VIRGINIA ELECTRIC AND POWER COMPANY  
RICHMOND, VIRGINIA 23261

Serial No. 16-146A  
NLOS/GDM R3  
Docket No. 50-281  
License No. DPR-37

**VIRGINIA ELECTRIC AND POWER COMPANY**  
**SURRY POWER STATION UNIT 2**  
**ASME SECTION XI INSERVICE INSPECTION PROGRAM**  
**RELIEF REQUESTS FOR LIMITED COVERAGE EXAMINATIONS**  
**PERFORMED IN THE FOURTH 10-YEAR INSERVICE INSPECTION INTERVAL**  
**RESPONSE TO REQUEST FOR ADDITIONAL INFORMATION**

Scan Diagram for Weld 1-07

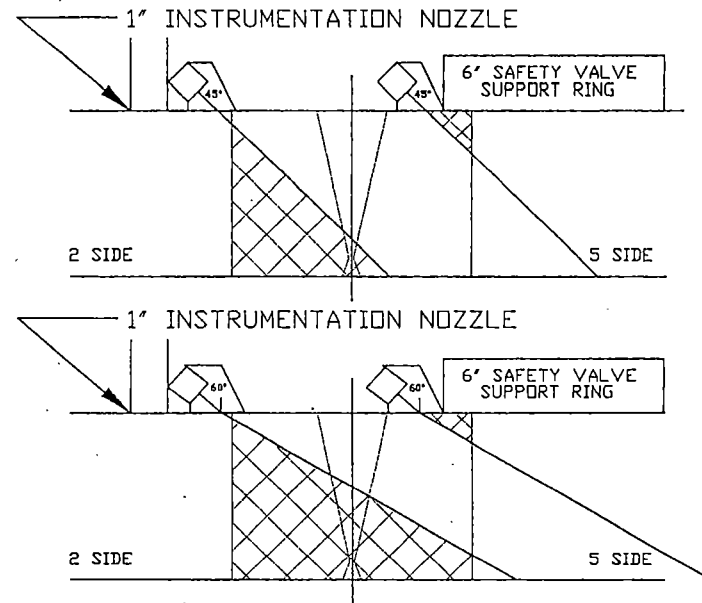
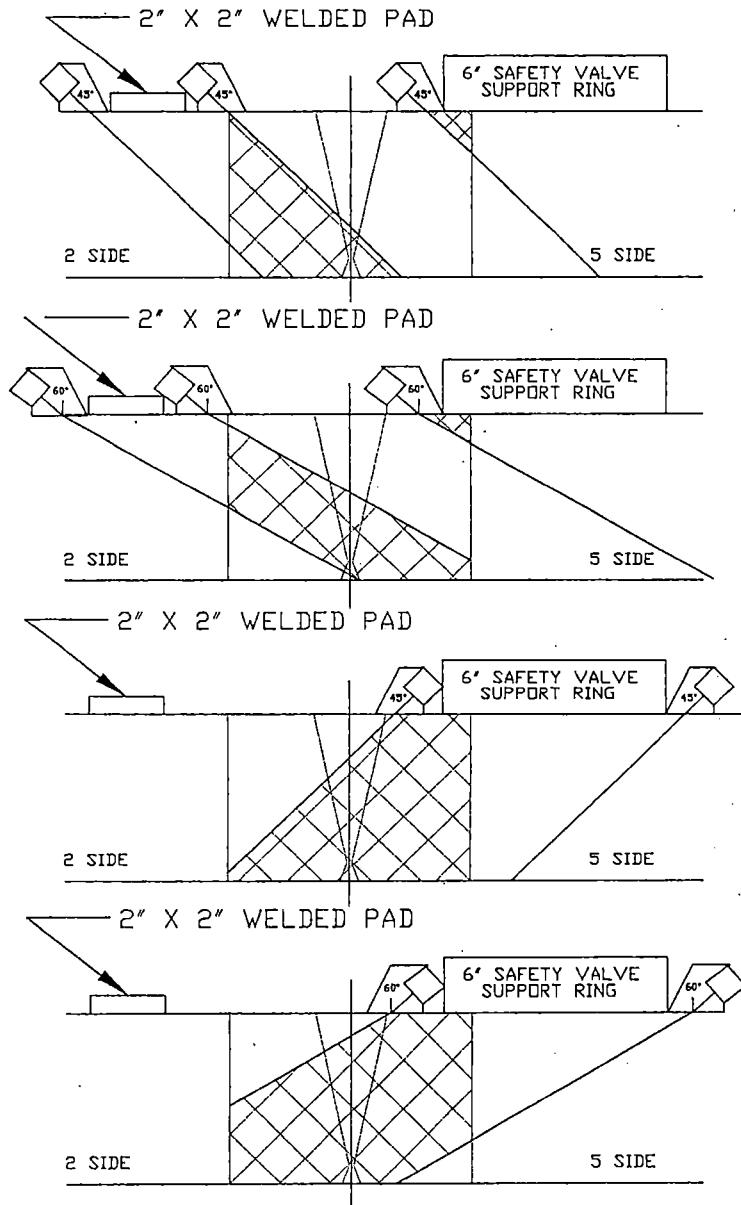
*With respect to relief request LMT-CO1, please provide coverage calculations and scan diagrams, similar to those submitted to the NRC by letter dated October 9, 2015 (ADAMS Accession Number ML15293A124) for the Surry, Unit 1 relief request LMT-CO1 (see pages 6 to 7 and 10 to 11 of Attachment 5 of the October 9, 2015 letter), and make clear in the diagrams that both scan directions, parallel and perpendicular to the subject welds, were performed.*

- Tabulation of percent volume by scan direction (coverage calculations) for Weld 1-02\*
- Tabulation of percent volume by scan direction (coverage calculations) for Weld 1-07\*
- Scan diagram for Weld 1-07\*

Weld 1-02 does not have an associated scan diagram. The limitation encountered during the ultrasonic testing (UT) examination of weld 1-02 is the support ring for the pressurizer insulation, which is attached to a component structural support for one of the power-operated relief valves (PORVs). The insulation support ring is 6 inches wide and covers approximately 4 inches (~1/3) of the 12 inches of longitudinal weld length. Although approximately 2/3 (~66%) of the weld was accessible, the coverage was conservatively calculated at 50% due to the interference of the support ring with the required scan areas. To be fully accessible, the required scan areas for the ultrasonic transducers must be available, and these dimensions are a function of the examination angle. The accessible portions of weld 1-02 were scanned in all possible directions (perpendicular and parallel to the weld) with the required examination angles (0°, 45° and 60°).

Regarding the scan directions for the subject welds, scans in both the parallel and perpendicular directions were performed during the fourth interval examinations. Documentation of the scans is provided in Figures 2 and 3 in Attachment 5 of the May 5, 2016 letter. Scan coverage is checked for upstream [perpendicular], downstream [perpendicular], CW (clockwise) [parallel], and CCW (counter-clockwise) [parallel].
